Revision "C"

MARYLAND DOT - STATE HIGHWAY ADMINISTRATION
Office of Traffic & Safety
TRAFFIC ENGINEERING DESIGN DIVISION
(Traffic Signal Plan)

US 1 at Amberton Drive / Hillside Drive

DRAWN BY:	Tom Zaydel	F.A.P. NO.	N/A	TS NO. 1873C	SHEET NO.
CHECKED BY:	Thomas Zaydel	S.H.A. NO.	HO-619-509-785		
SCALE:	1" = 20'	COUNTY:	Howard	T.I.M.S. NO. H967	1 OF 2
DATE:	August, 2000	LOG MILE:	13000107.78

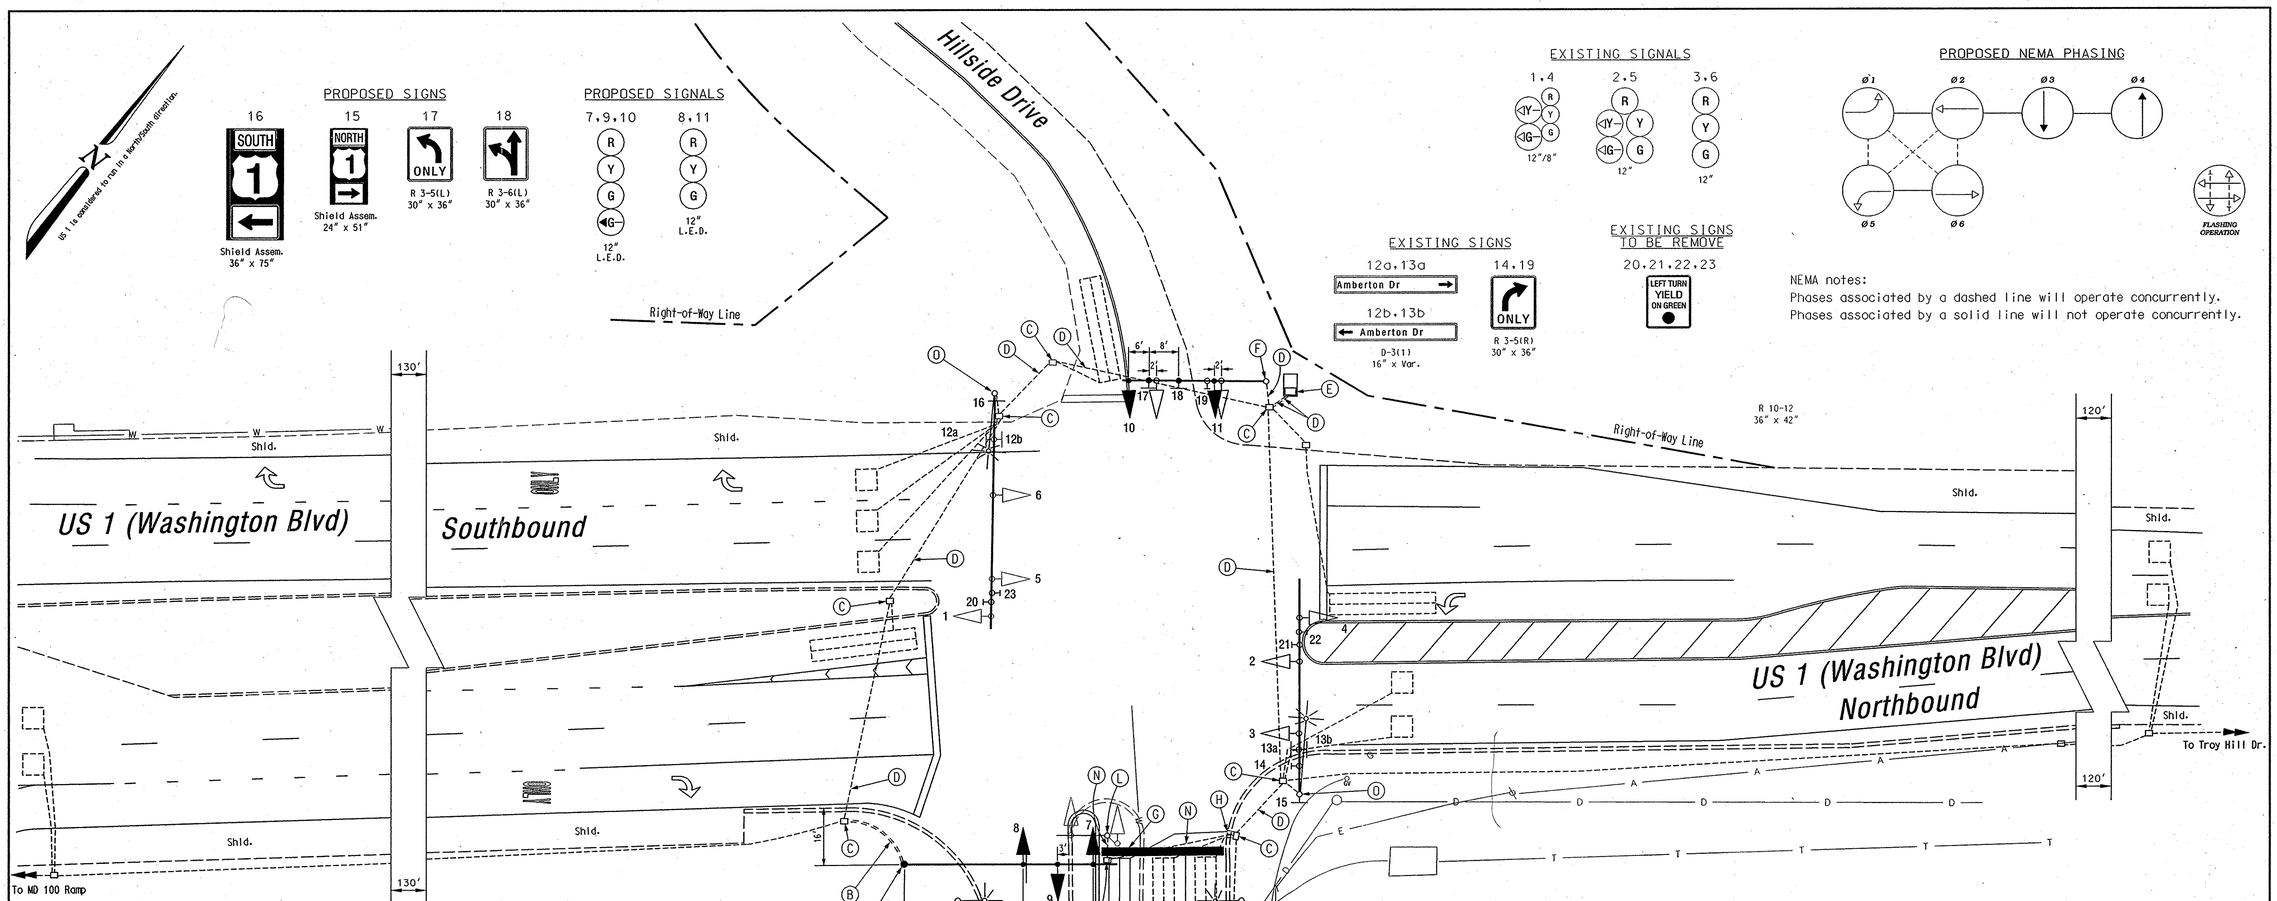
C	October 25, 2006 Remove & replace pole and mast arm on east leg. BW996M82			
HJK	GR			
B	October, 1999 Ultimate signal S.H.A. No. AW850-301-070			
JDM	DD	DAZ	EP	TH
A	October, 1999 Signal redesign due to temporary geometric. AW850-301-070			
JDM	DD	DAZ	EP	TH
